**DATE:** 03.27.2014  
**TO:** ProTrak  
**FROM:** Bill McDow  
 Transportation Planning

■ **TEMPLE OF ISRAEL SCHOOL/SOCIAL CENTER [Plan Review# 2]**

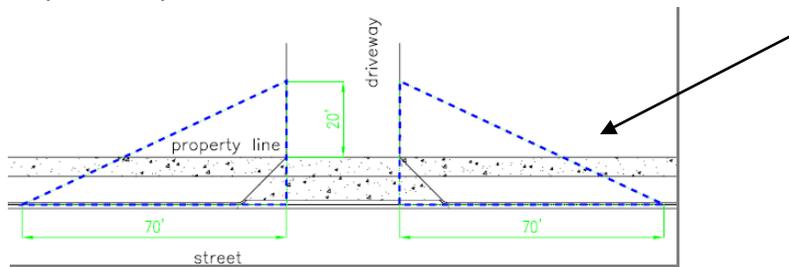
2. The one-way driveway width should be 13’ in width plus the driveway flares sections (measured at the property line). The proposed driveway was shown with a 27.0’ entrance width and 29.3’ exit width.
3. Technical Standards for one-way driveways on One-Way Streets require a smaller foot print for the Driveway and Taper sections, (per Table 4 One-Way Street-Right side), which allow 13’ on the entrance taper and 3’ for the exit taper. Since the turn into the driveway and the exit from

the driveway are both right turns, full tapers are only required on the turning side of the driveway entrance/ exit. [Chapter VII, C, Table 4, CofWTSSM]
